REQUEST

Current Zoning: R-5 (single family residential)
Proposed Zoning: UR-1(CD) (urban residential, conditional)

Approximately 0.36 acres located at the southeast intersection of Matheson Avenue and Pinckney Avenue, west of Clemson Avenue.

The petition proposes to allow a single family detached home and a duplex on a vacant parcel.

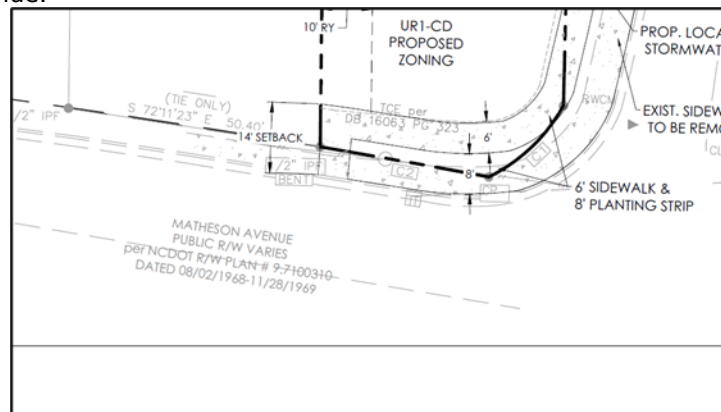
1. ~~Curbline: The proposed zoning district has a setback measured from back of the existing or proposed future curbline.~~
 - a. ~~Matheson Avenue: Curb and gutter to be 27 feet measured from centerline to back of curb.~~

~~Label and dimension existing curbline location on site plan measured from centerline of Matheson Avenue.~~

2. ~~Revise site plan and conditional note(s) to commit to dedicate 40 feet of right-of-way along Matheson Avenue measured from the road centerline. The site plan shall label and dimension the right-of-way from the road centerline.~~

3. ~~Revise site plan and conditional note(s) to commit to construct an 8-foot planting strip, and 6-foot sidewalk on Matheson Avenue and Pinckney Avenue per Chapter 19. The site plan shall label and dimension both items from the back of curb and gutter. Add streetscape commitments to conditional notes section of the Rezoning Plan.~~

4. ~~Revise site plan and conditional note(s) to show proposed intersection and frontage improvements of Matheson Avenue Road Conversion project project that is being done by the City's CIP project. These improvements can be shown as "by others" and in grayscale. The project scope includes converting Matheson Avenue from 4 lanes to 2 lanes, construct raised 2-way cycle track on south side of Matheson Avenue. These improvements to be coordinated with General Services and CDOT during the permitting process.~~

5. ~~Remove CDOT Notes from site plan.~~

5. TRANSPORTATION

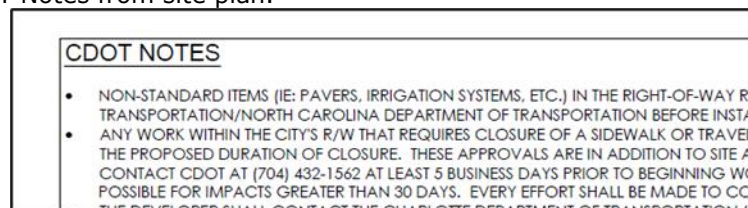
6. ~~Revise conditional note 5.A) by replacing NCDOT with CDOT as Pinckney Avenue is City-maintained.~~

A) VEHICULAR ACCESS WILL BE AS GENERALLY DEPICTED ON THE REZONING PLAN. THE PLACEMENT AND CONFIGURATION OF THE VEHICULAR ACCESS POINT SHOWN ON THE REZONING PLAN IS SUBJECT TO ANY MINOR MODIFICATIONS REQUIRED TO ACCOMMODATE FINAL SITE AND CONSTRUCTION PLANS AND DESIGNS AND TO ANY ADJUSTMENTS REQUIRED BY NCDOT FOR APPROVAL.
